Product/Process Change Notice (PCN)

PCN #: PCN_ConMPC3_20160722

Product Affected: 6620xx236022 6621xx236022
 6620xx230822 6621xx230822 6620xx231722
 6621xx231722 6620xx2308222

DETAIL OF CHANGE:

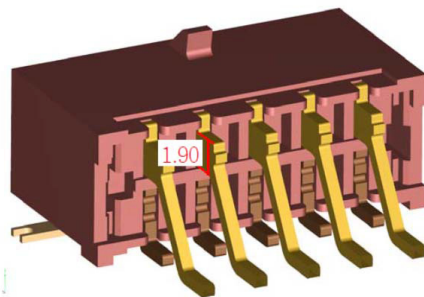
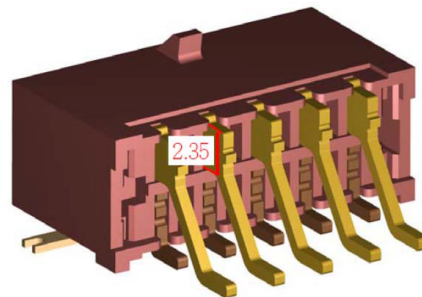
In order to increase the production efficiency, the design of upper row pins will be changed. Products after product change with effective date of November 5th, 2016 are available with Date Code from 2016-11-01.

The external design, at plastic body base, of upper row pins will be changed to a bigger size to increase the efficiency of the assembling process.
